Project: IEEE P802.15 Working Group for Wireless Personal Area Networks (WPANs)

Submission Title: assigned comments for draft D3

Abstract: proposes comment resolutions for a set of CIDs

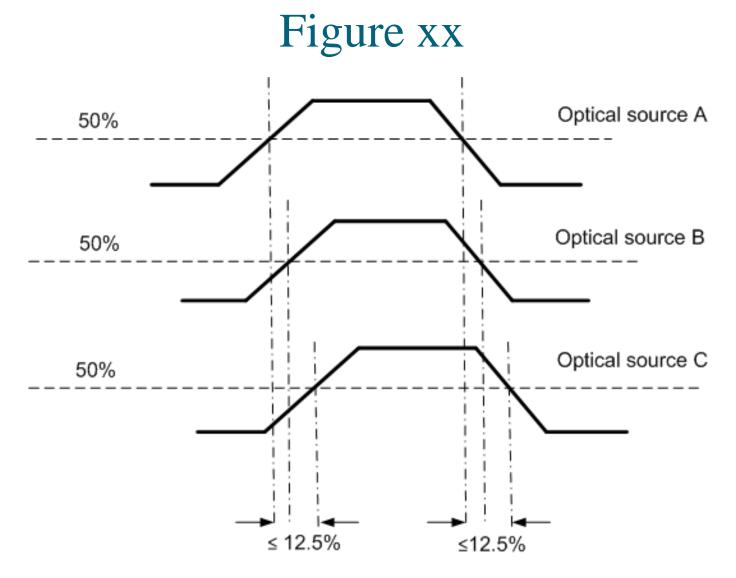
the following text is confusing: "maximum spread between the clock edges at the output of the optical source ...". I don't believe that the output of an optical source (which is just photons) has a true clock edge.

Maybe a better way to state the requirement is to say when the signal reaches 90% of maximum insensity and that this time has to be within 12.5% of the clock period.

Replace last sentence at 5.1.5 with

Figure xx shows the allowable spread at the output of the optical sources, assuming a synchronized digital input. The maximum spread at 50% of the signal intensity during the rise and fall time at the output of the optical sources shall not vary by more than 12.5% of the clock period.

Add Figure xx in 5.1.5
